ADDENDUM #1
Schultz Pathway and Boardwalk

Addendum #1 includes the following revisions:

RE: SCHULTZ PATHWAY AND BOARDWALK

BOARDWALK ELEVATION
SCALE: 1" = 3'

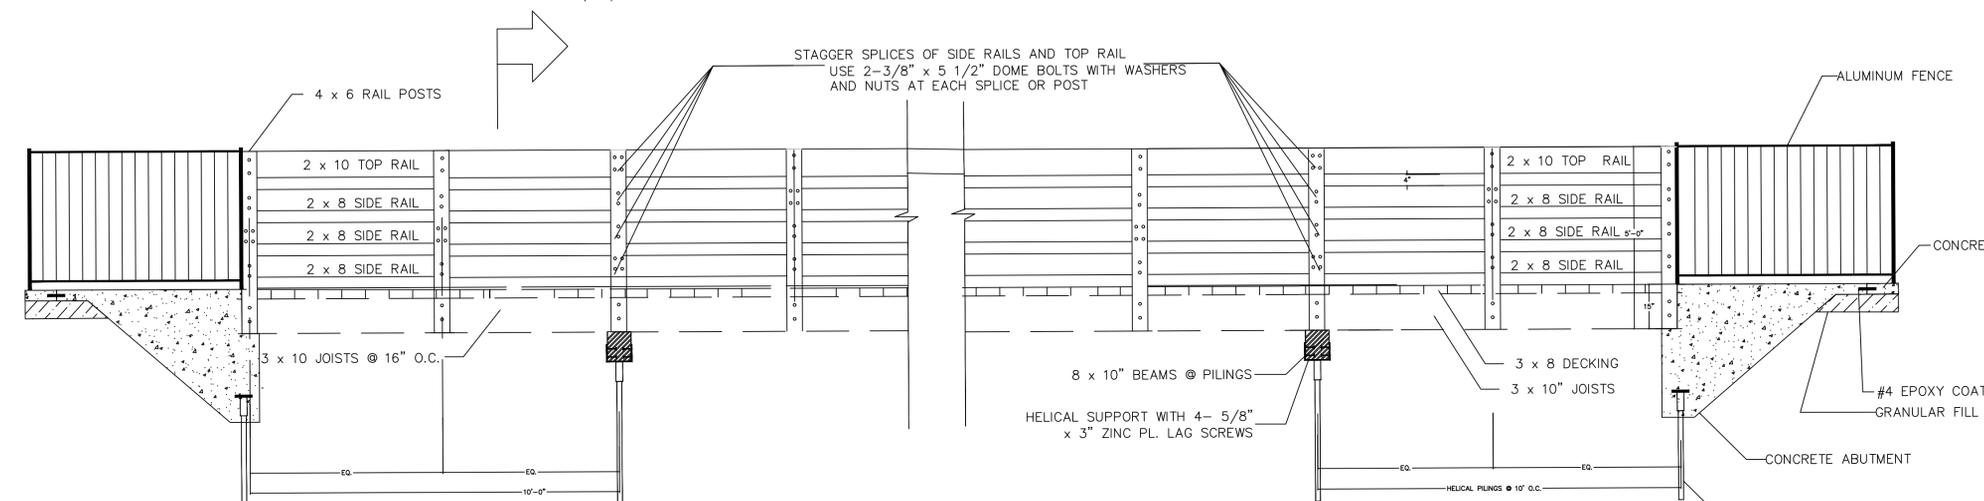
1. Sheet 8 – Boardwalk Details
 - The size of the deck screws have been changed to #10 x 5”
 - The helical note on the Boardwalk Elevation has been revised to state that two helicals will be located under each abutment.
 - Section A-A has been revised to include cross bracing. Cross bracing shall be included in the helical pile design.
2. Sheet 9 – Boardwalk Details
 - The Beam/Joist/Post Detail note regarding helicals has been revised to state that two helicals will be located under each abutment
